A comment on Table 88-7 and 88-8 in Draft 1.0

IEEE802.3 ba Task Force
9-13 November 2008

Level diagram per lane as per 100GBASE-LR4 baseline

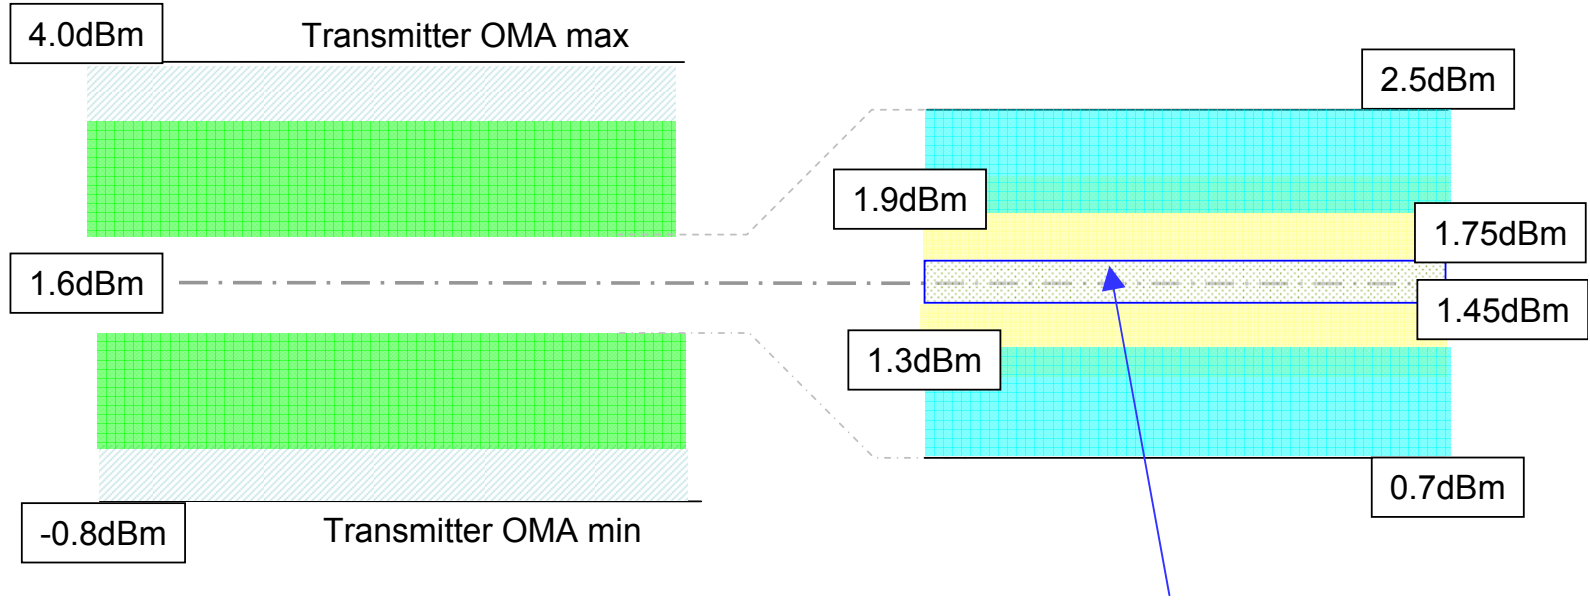
- ✓ The Transmitter launch OMA range is from -0.8dBm to 4.0dBm
- ✓ The range of 4.8dB is 1.66dB less than that in the 40GBASE-LR4.(See appendix)

Very narrow margin in Transmitter launch OMA for 100GBASE – LR4

Level Diagram reflected the proposed remedies

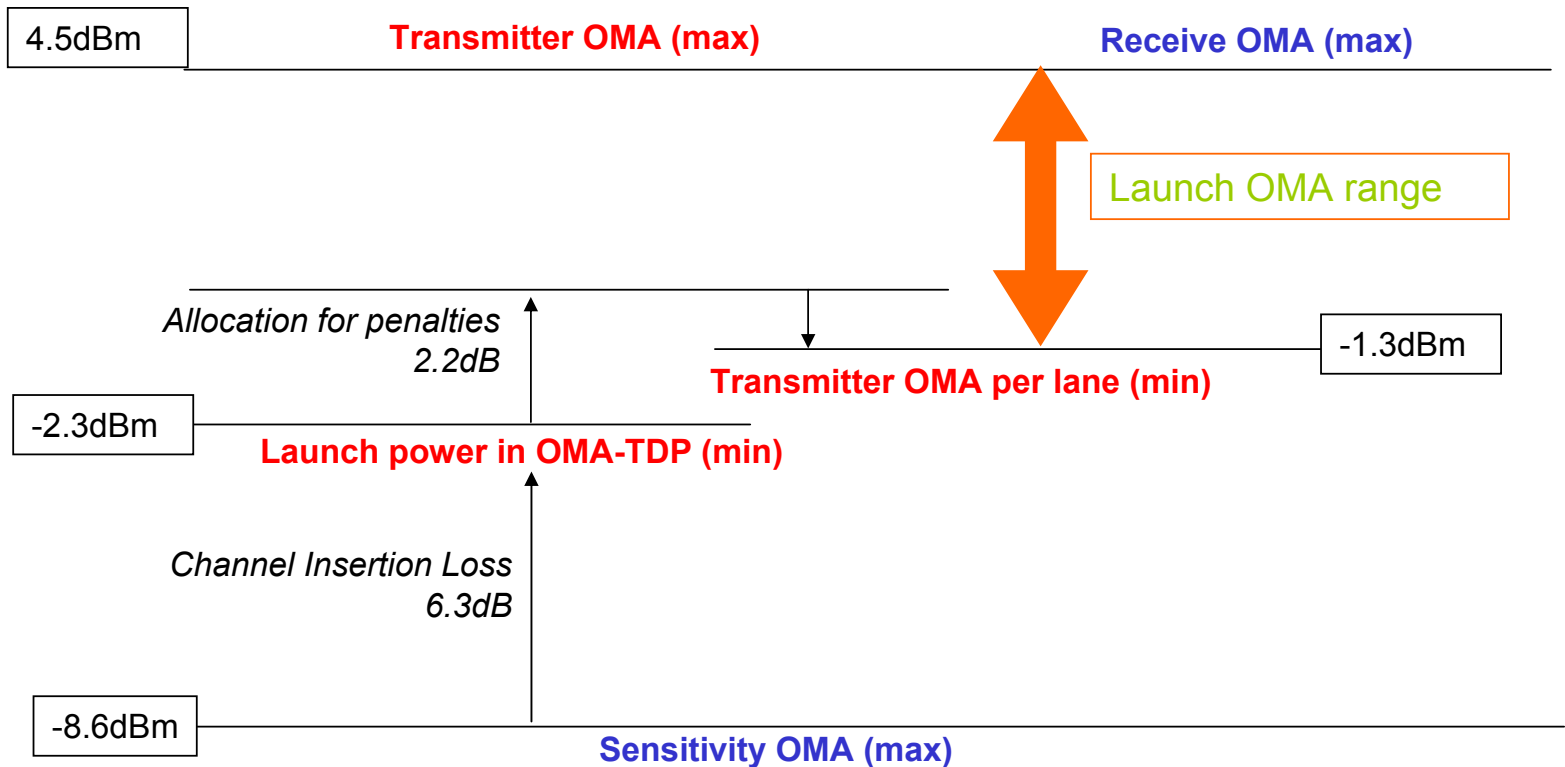
- ✓ The launch OMA range of 5.8dB is comparable to that in the 40GBASE-LR4.(See appendix)
- ✓ The values of several parameters in Table 88-7, 88-8 should be reviewed due to these remedies

- The remedy is :
 - Transmitter launch OMA max shall be changed from 4.0dBm to 4.5dBm
 - Transmitter Average launch (max) is changed from 4.0dBm to 4.5dBm
 - Receiver OMA sensitivity shall be changed from -8.1dBm to -8.6dBm

Level diagram per lane as per 40GBASE-LR4 baseline (ER=5.0dB)

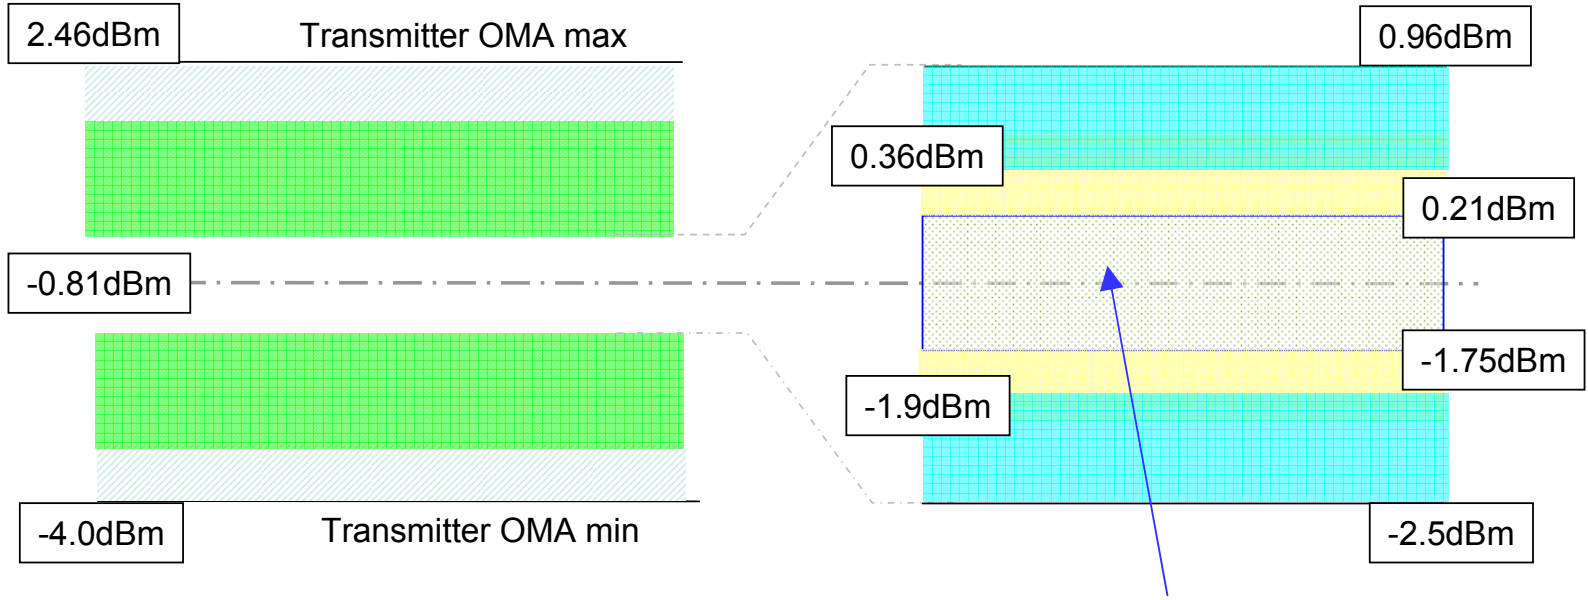
Margin in Transmitter launch OMA for 40GBASE – LR4

margin : 1.96dB
